MEMORANDUM

FROM: Matt Jesick, Case Manager

DATE: October 12, 2018

SUBJECT: BZA #19841 – 900 55th Street, NE – Special Exception to permit multiple buildings on a single record lot

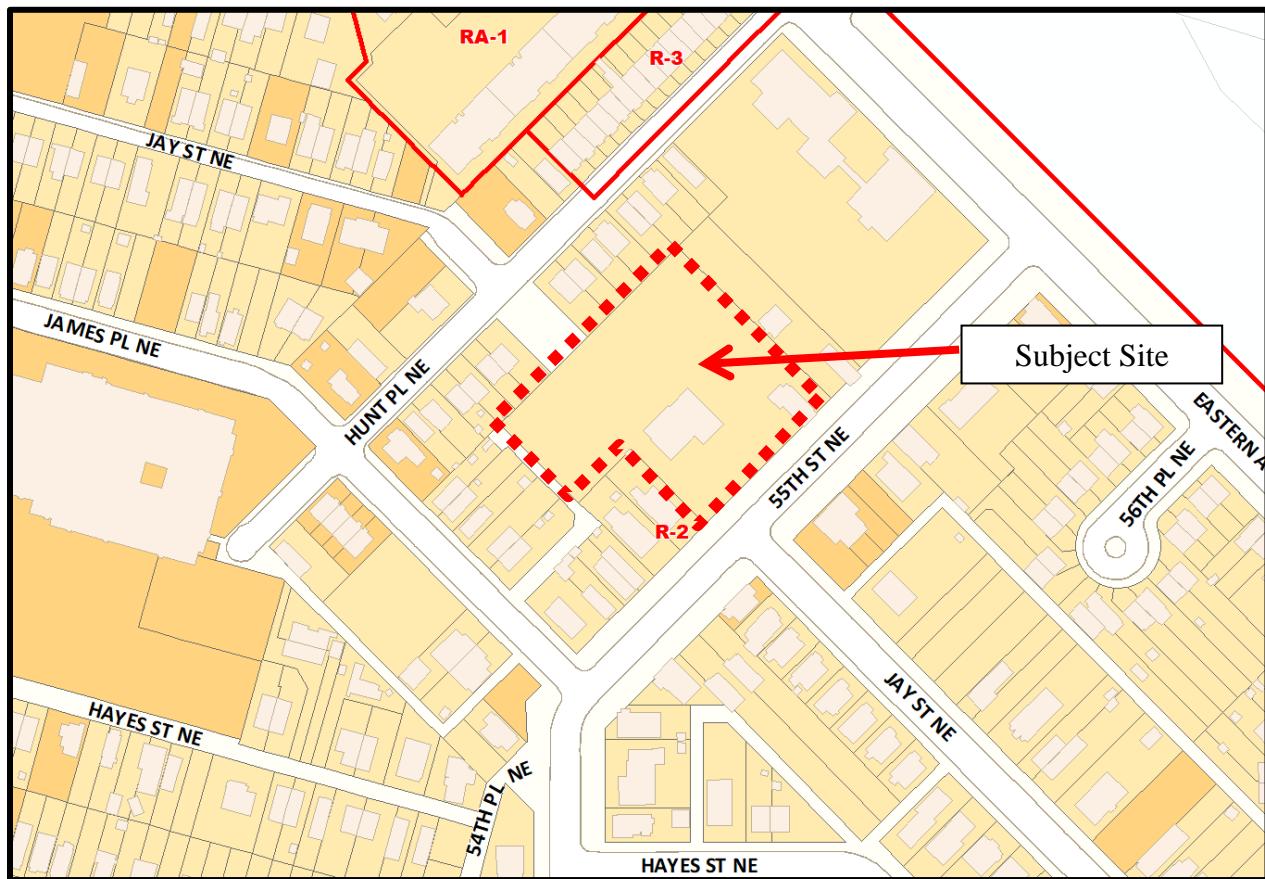
In this case, the record (Exhibit 36) indicates that the District Department of Transportation (DDOT) has concerns with the site plan, although it does not appear to express concerns with the proposed number of units or the concept of a theoretical lot subdivision. DDOT also notes that some public space requirements necessary to the proposed site plan may not be approved. Their report includes a draft concept for alternate site access.

OP has had discussions with DDOT regarding this issue, and agrees with DDOT's general assessment of the site plan, that revisions could result in a site plan and design that is more in character with the surrounding neighborhood, and more consistent with the review criteria for a theoretical lot subdivision application.

While the potential site plan and circulation advantages of the submitted DDOT sketch plan are clear, OP feels it is appropriate and desirable to have the applicant present both their concerns with that (or any other) site plan, and the benefits of their proposed site plan.

FIGURE D103.1
DEAD-END FIRE APPARATUS ACCESS ROAD TURNAROUND

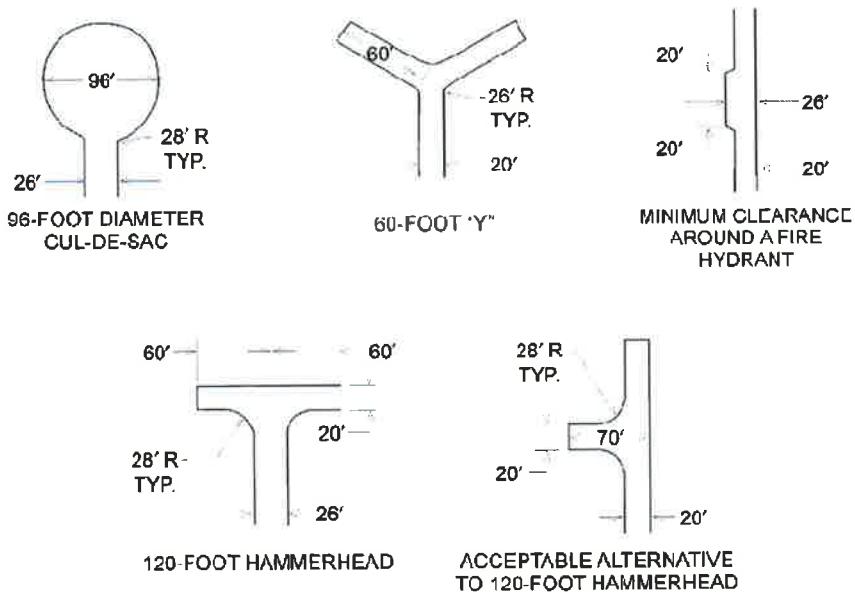
D103.4 Dead ends. Dead-end fire apparatus access roads in excess of 150 feet (45 720 mm) shall be provided with width and turnaround provisions in accordance with Table below:

LENGTH H (feet)	WIDTH H (feet)	TURNAROUNDS REQUIRED
0-150	20	None required
151-500	20	120-foot Hammerhead, 60-foot "Y" or 96-foot diameter cul-de-sac in accordance with Figure D103.1
501-750	26	120-foot Hammerhead, 60-foot "Y" or 96-foot diameter cul-de-sac in accordance with Figure D103.1
Over 750	Special approval required
